Anglia Square,
Norwich
Transport RevC Note

To: **Norwich City Council / Norfolk County Council**
From: **Iceni Projects (Transportation)**
Date: **January 2023**
Title: **Anglia Square, Norwich – Revision C Note**

3. Following on from the July 2022 Transport Assessment Addendum (RevA) submission, further amendments have been made to the proposed development as the scheme has evolved through consultation, which will be submitted as part of a Revision C submission. This note outlines the new proposals and how it compares to the previous Transport Assessment Addendum (RevA).

SITE LAYOUT REVIEW
 (REFUSE VEHICLE)

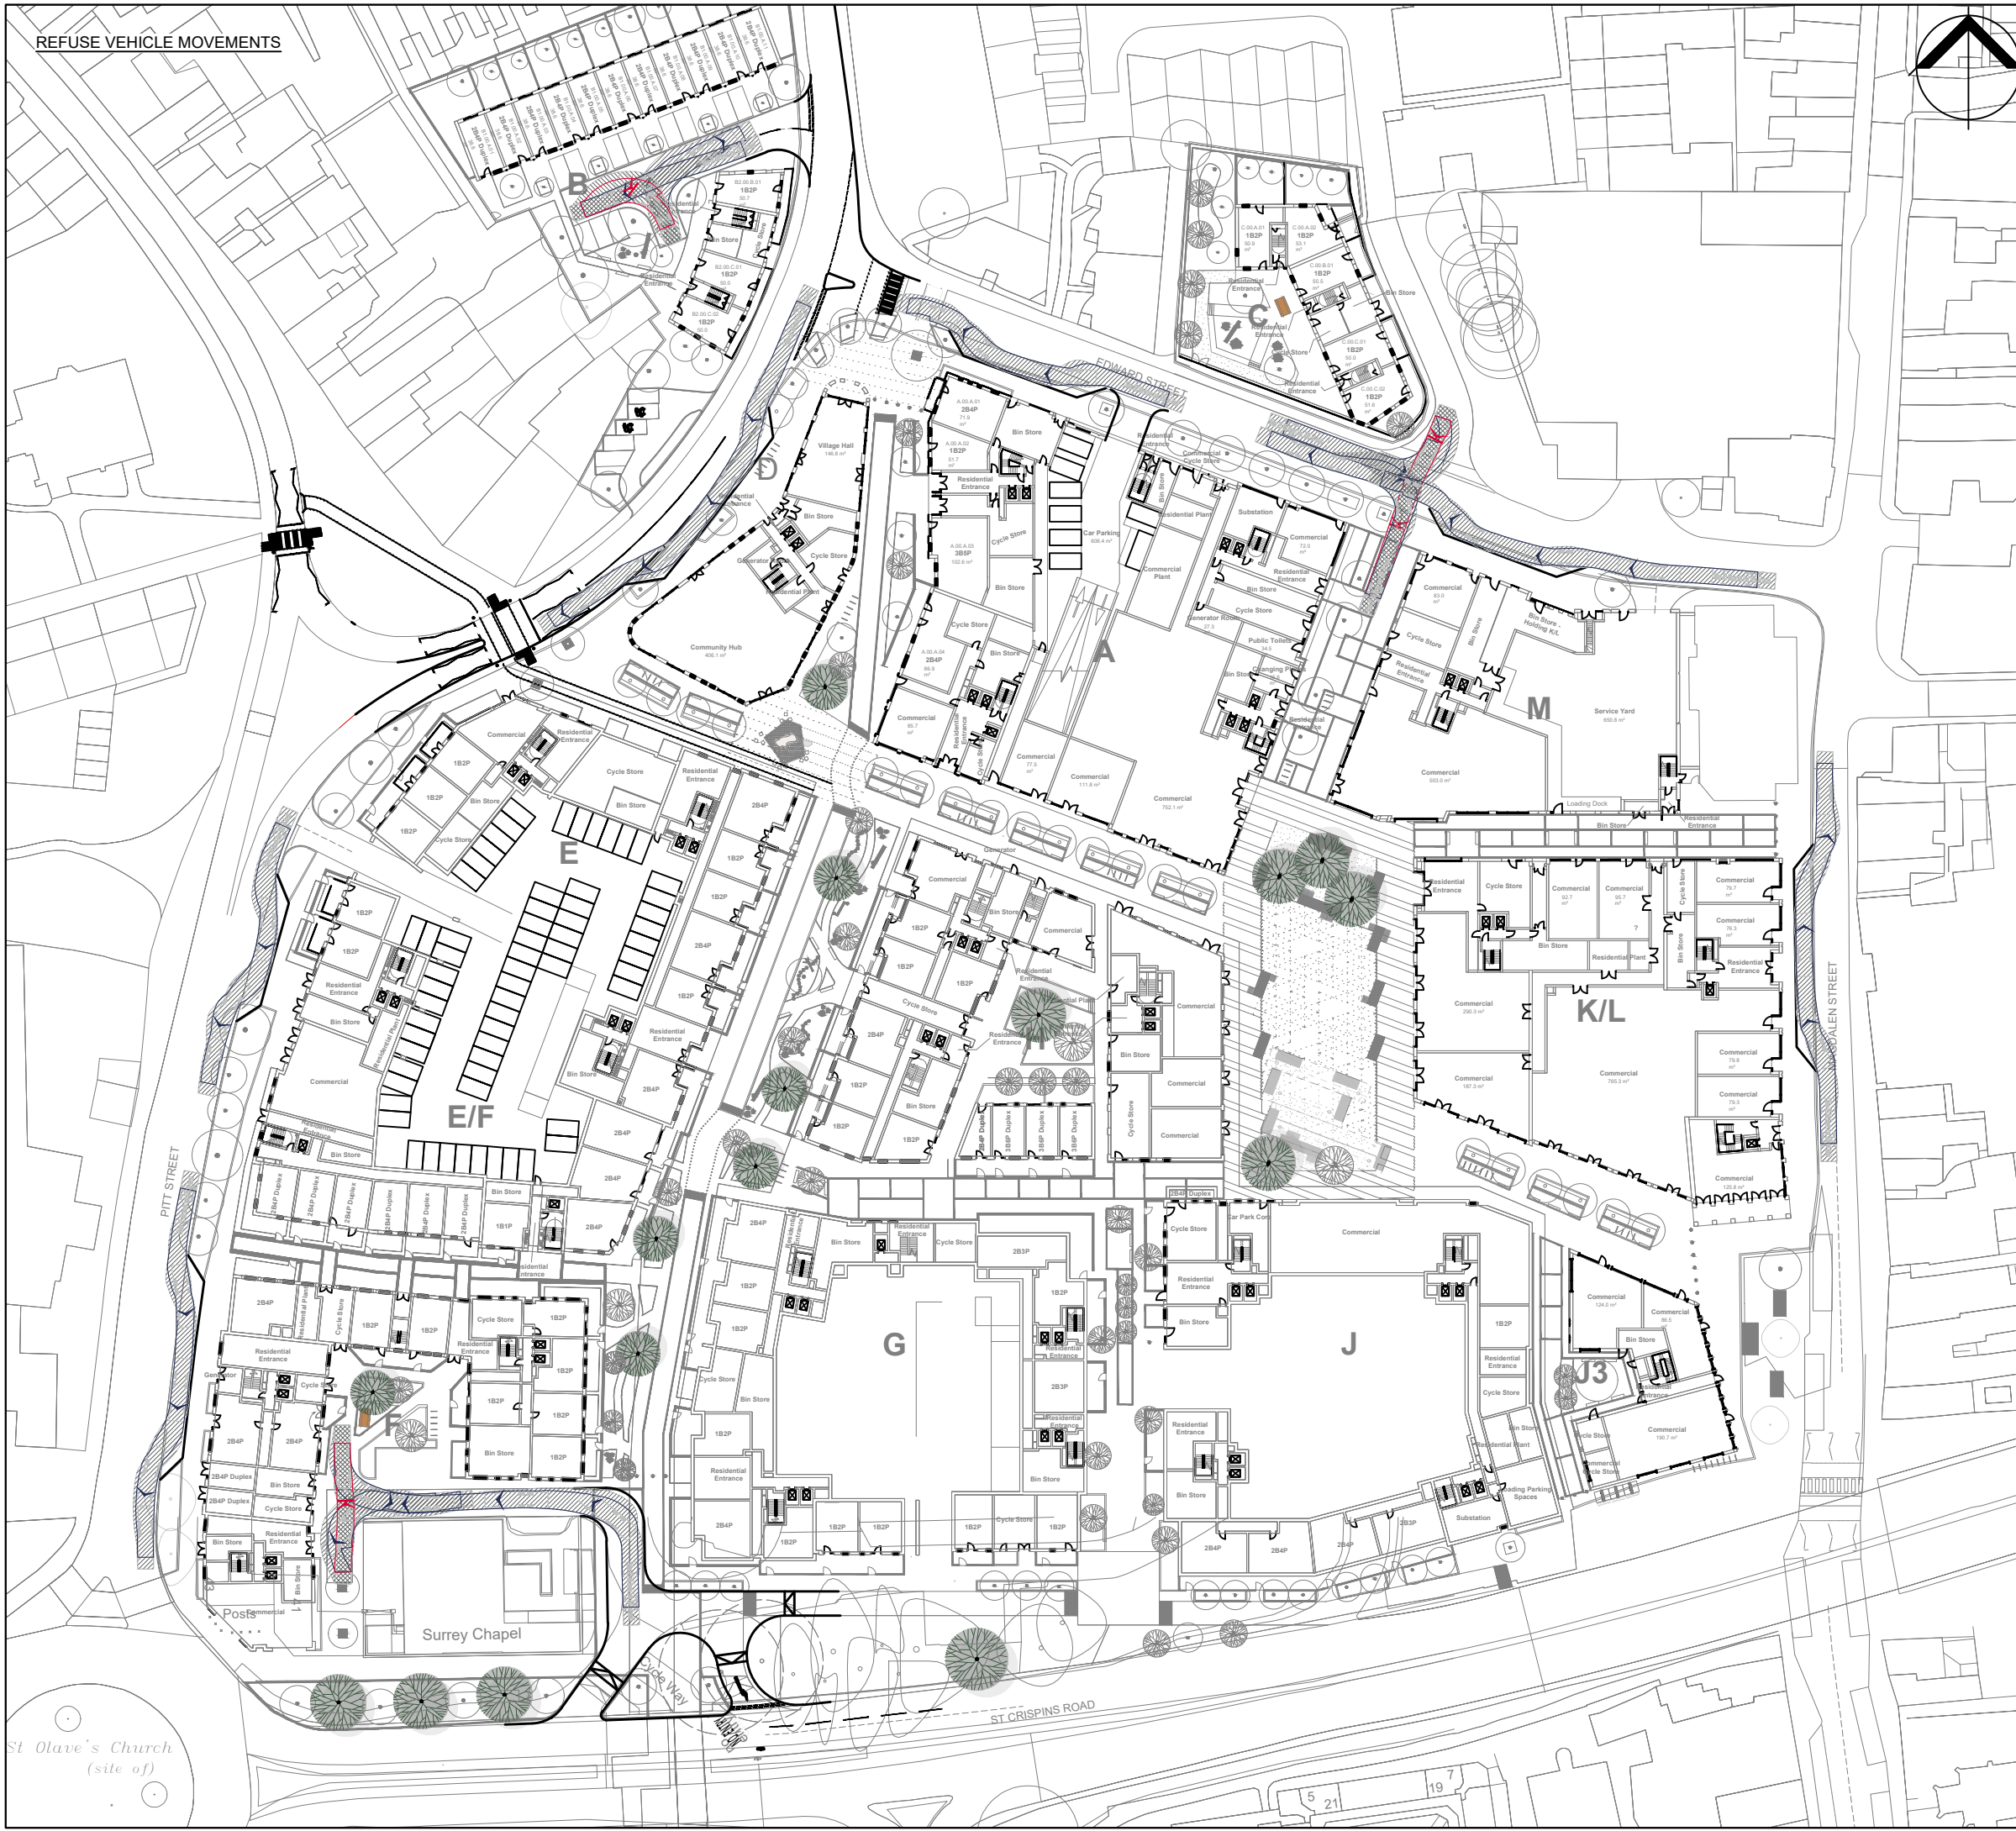
<p>None</p> <p>21-T123_41.1A</p> <p>21-T123_41.2A</p>	<p>21-T123_32G</p> <p>21-T123_45A</p> <p>21-T123_46A</p>	<p>In order to ensure that the development proposals allow for all vehicle movements. Further iterations to the previous tracking proposals have been produced. These drawings show car, refuse vehicle, and fire tender vehicle movements throughout the site.</p> <p>The tracking drawings show that the area provided for vehicle movements is sufficient and does not impact on the surrounding landscaping/building edge detailing.</p>	<p>These changes are all minor amendments and are not considered as a material change to the planning application.</p>

Revision C Proposals	Comments
Block A – Ground floor internal cycle storage and refuse store swapped position to allow refuse strategy to comply with NCC standards.	<p>This is deemed acceptable and accords with refuse worker carry distances. A drawing showing the new refuse vehicle movement can be found in Appendix A3.</p> <p>This change is a minor amendment and is not considered as a material change to the planning application.</p>
Block B – 2 x driveway parking spaces to houses relocated within courtyard, layout of front garden/driveway/path to 11no. houses amended with private bins and bike stores added.	<p>This is deemed acceptable and accords with refuse worker carry distances as well as cycle standards.</p> <p>This change is a minor amendment and is not considered as a material change to the planning application.</p>
Block B – Error on schedule Block B states 12 car parking spaces. there are 11 spaces in Block B.	<p>This is deemed acceptable as this conforms with the 0.40 spaces per dwellings requirement as per the comments received from NCC on the original Call in Scheme.</p> <p>This change is a minor amendment and is not considered as a material change to the planning application.</p>
